#2015-63 Crystal Lake South High School
Project Review for Planning and Zoning Commission

Meeting Date: January 20, 2016

Requests: 1. Special Use Permit (Section 2-400) for a high school for existing South High School.
2. Special Use Permit (Section 4-600D) for accessory structures over 900 square feet.
2. Variations for:

SHEET: 2 OF 2

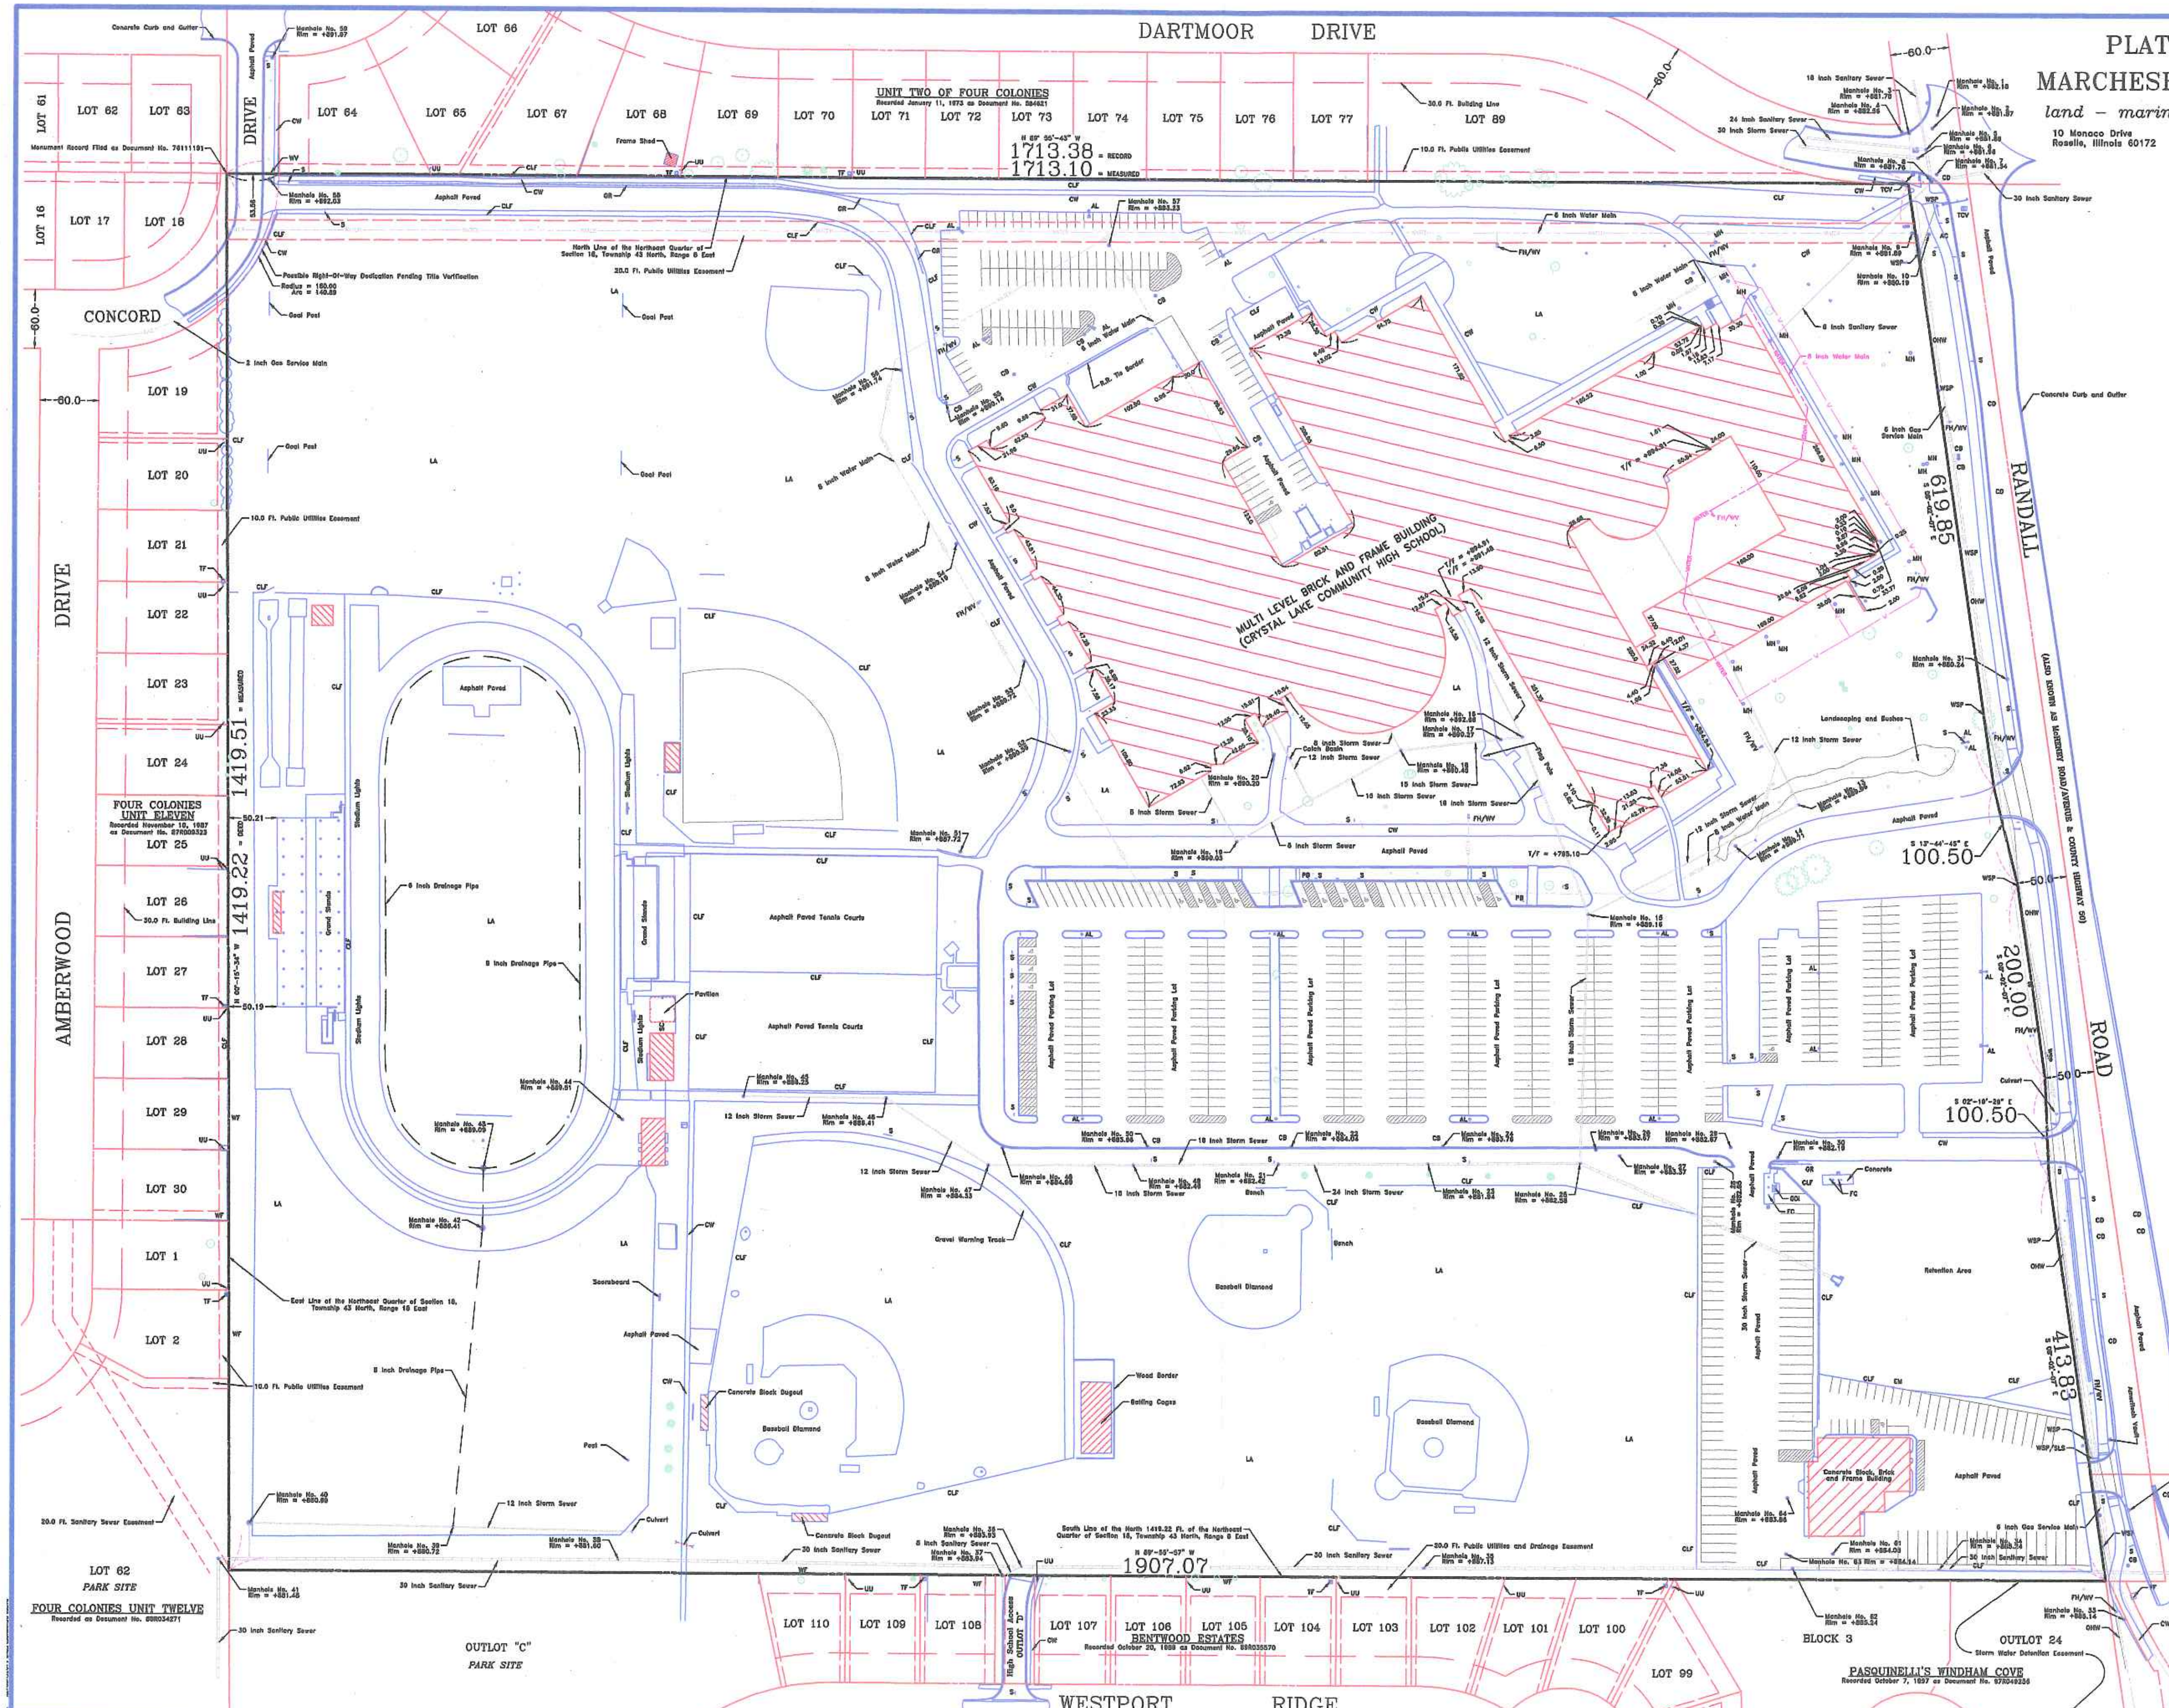
2. Site Plan
   A) The plat of survey at the northwest corner of the site indicates Concord Drive traverses the School District's property. This right-of-way was dedicated with Four Colonies Unit 11 and should be corrected on the survey.

J14 ELEVATION/SECTION - PROPOSED EAST BLEACHERS W/ RELOCATED PRESSBOX & WEST BLEACHERS

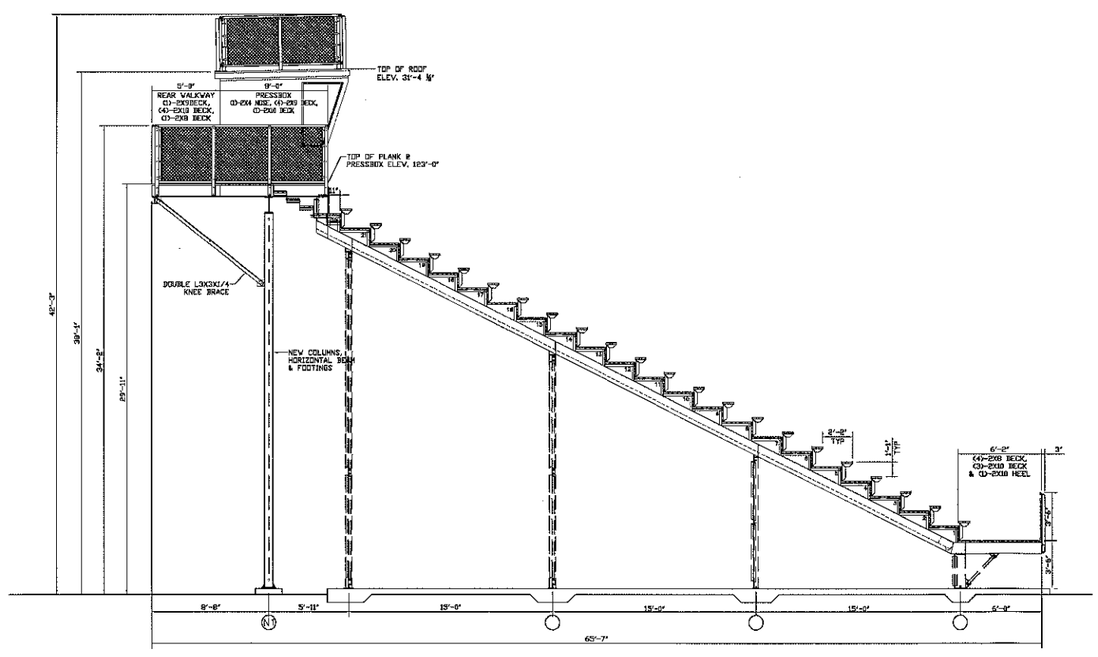
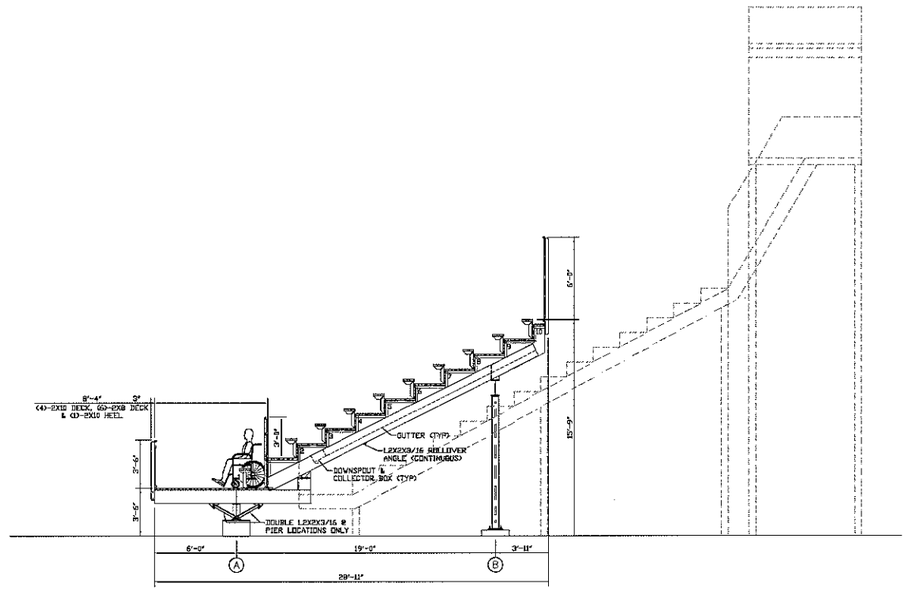
4. Bleachers
   A) The plans do not provide specific details on the screening fence on the west-side bleachers. The west-side bleachers screening fence may be chain-link with neutral colored privacy slat inserts. The final details of all proposed fencing must be submitted for review and approval by staff.

A1 LANDSCAPE PLAN
SCALE: 1" = 30'-0"

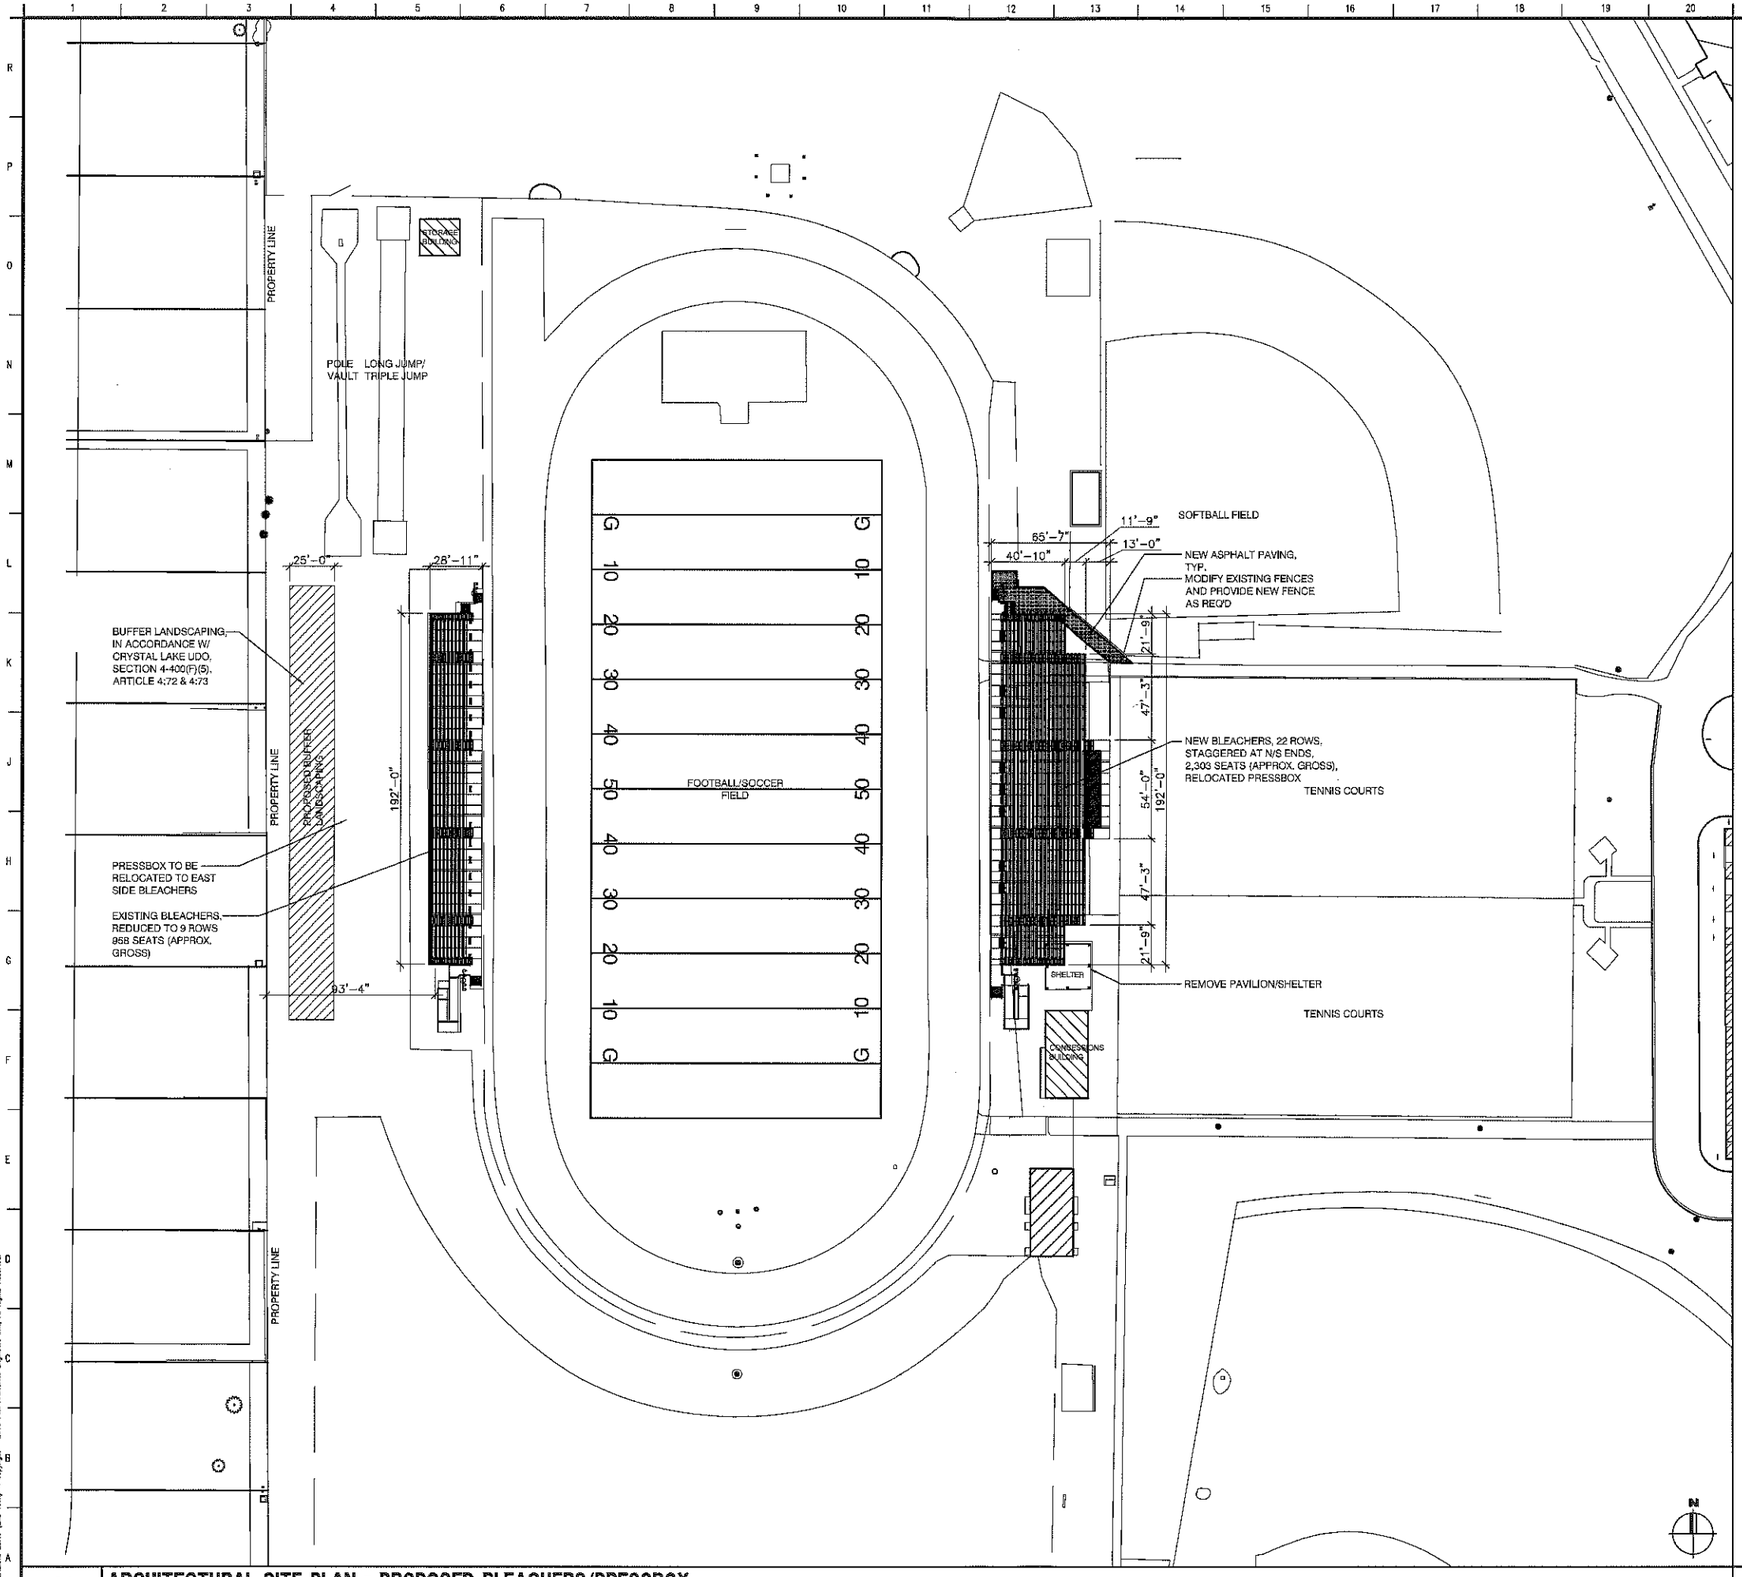
6. Landscape Plan
   A) Indicate the location of the existing chain link fence west of the football field and its relation to the proposed landscape screen. It may be beneficial to keep the existing fence in place and located the proposed landscaping as close to the fence as practical on the east side, allowing for more room for stormwater conveyance to the west.
   B) Extend a landscape screening material for the single family homes to the north and south to completely screen the west-side bleachers.
   C) The landscape screening material must be planted as soon as practical to establish the plants early and maintained as long as the bleachers are present. Provide a maintenance plan for the landscape screen to the City.
   D) Substitute the proposed grasses shown in the area along the rear yards of the single family homes for a more maintainable vegetated cover.
